RE: RCRA Group 5 SSFL  
Comments for Santa Susana  
Field Laboratory Areas III and  
IV as defined within the RCRA  
group guidelines

Ms. Laura Rainey  
Senior Engineering Geologist  
Department of Toxic Substance Control  
5796 Corporate Avenue  
Cypress, CA 90630

Figure S.1-1 RIHL RFI Site

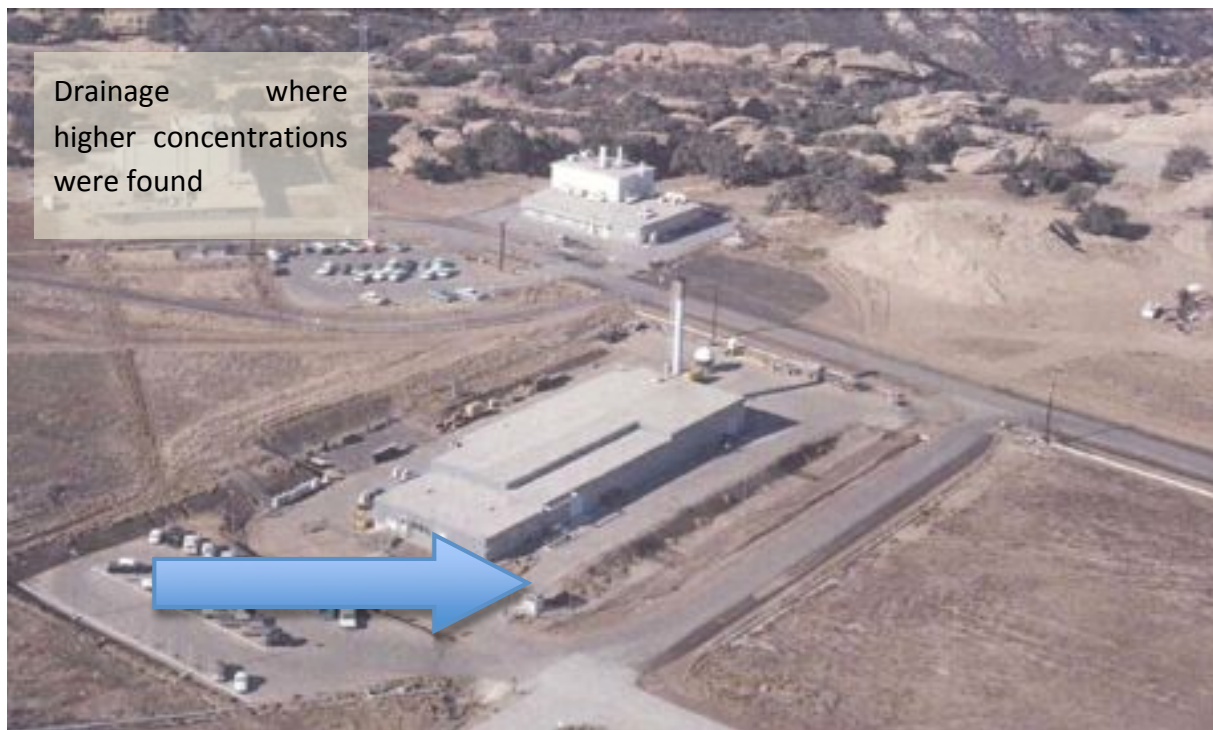
Location of the UT07 Radwaste underground storage tank is not identified. When unknown operational use dates, and location is also not known, we ask that much more thorough investigation of this tank be done. We request that ultimate disposal information also be provided.

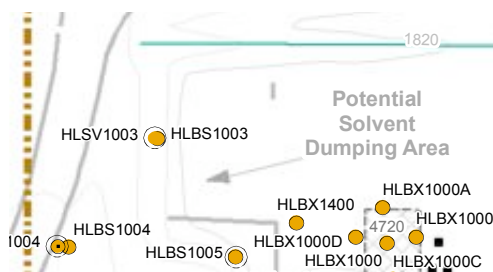
Behind these giant vaults were offices where workers sat in an office environment with their backs to the vaults.

### STL-IV Storable Propellants

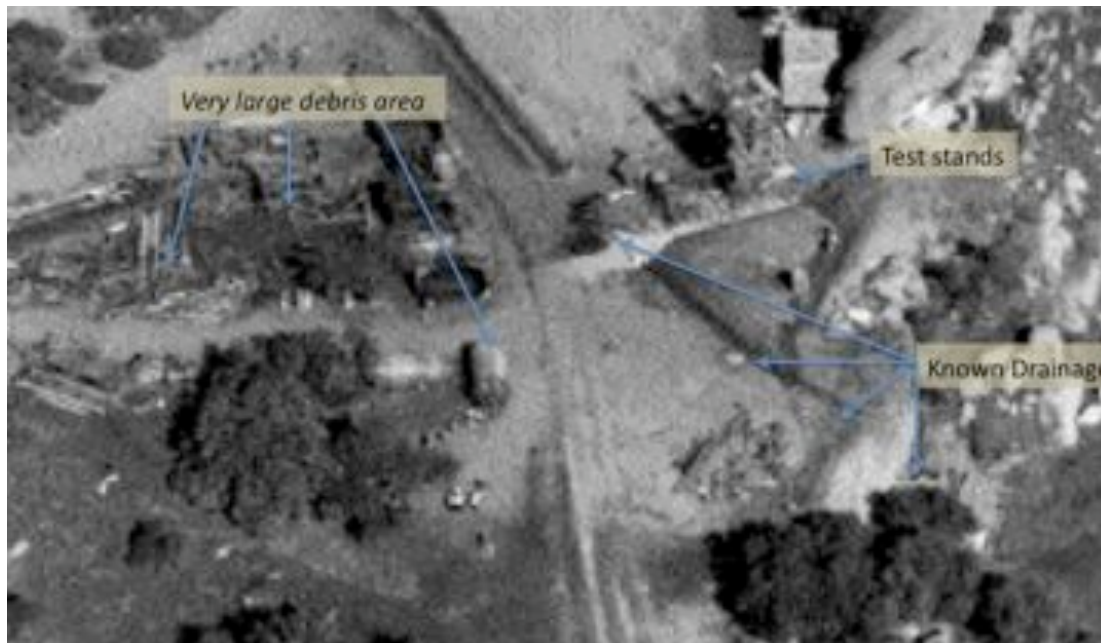
Looking closely at this area, in addition to the very extreme soil disturbance that is visible (lower right, pictured above), this area also receives the run-off from the storage area located behind the rock, as well as the main drainage as demonstrated in the following photographs.

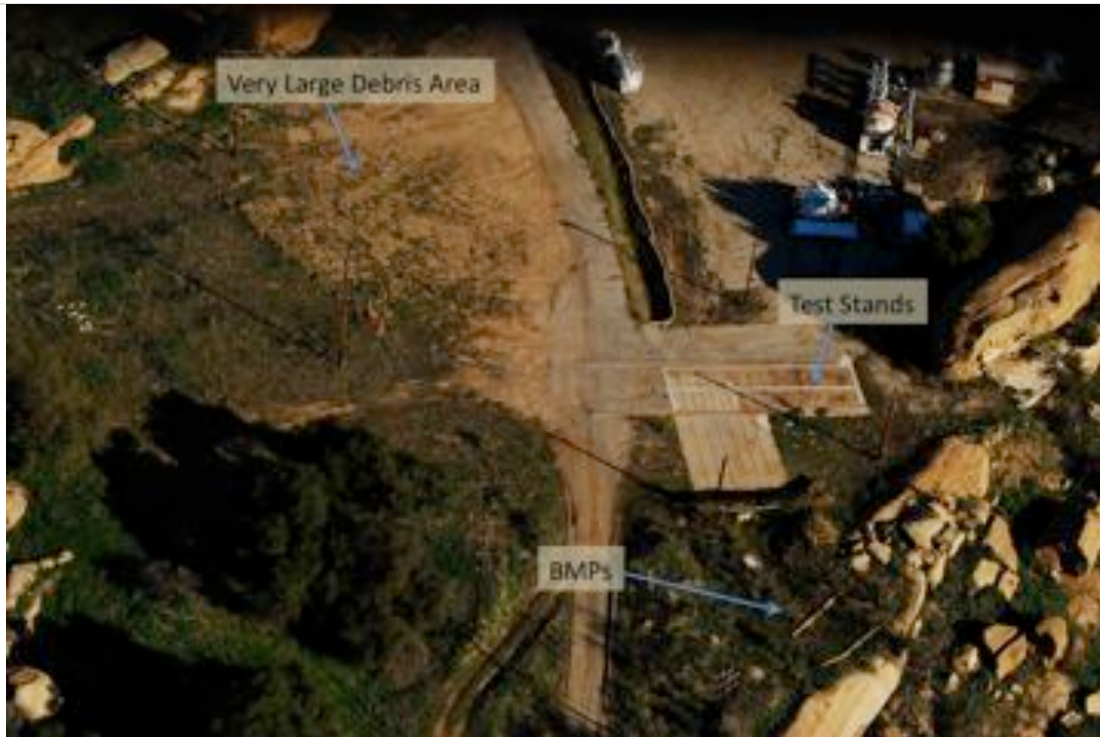
VOCs in Soil Vapor, STL IV RFI Site<sup>13</sup> shows areas with elevated soil vapor detections near the former “clean room” trailer and the area where specific effluent from sinks and other operational facilities inside, has not been adequately sampled based on this report. In addition, the elevated detections appear to be ignored. These areas, which clearly have contaminants present, need to be part of the CMS Corrective Measures Study (V-368).

Energetics in Soil STL RFI Site<sup>14</sup> does not adequately address the area known for storage of energetics. There simply are no samples in the area, so nothing can really be known by this figure. This lower area is not adequately looked at for all constituents of concern, with limited figures available for review.

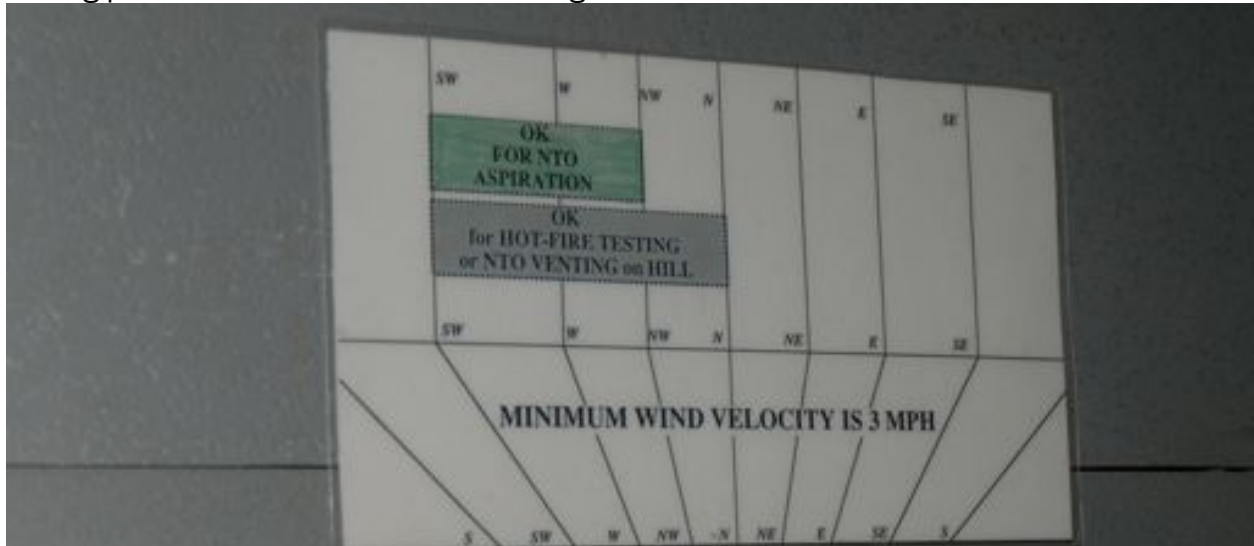
Energetics and MMH highly reactive storage was located here in addition to evidence of debris down the drainage toward outfall 2 below.

This area is not adequately addressed in Appendix U debris documentation and should be sampled for all COPCs related to the STL IV facility.

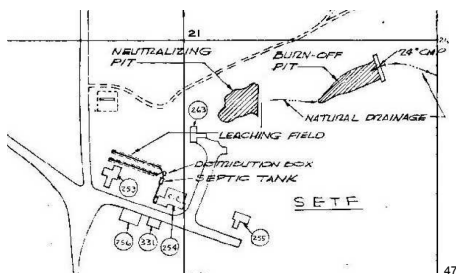
Shown below is an aerial photograph of the lower "shark area" where there has clearly been activity. We believe that comparison photos for usage during the "borrow soil" programs
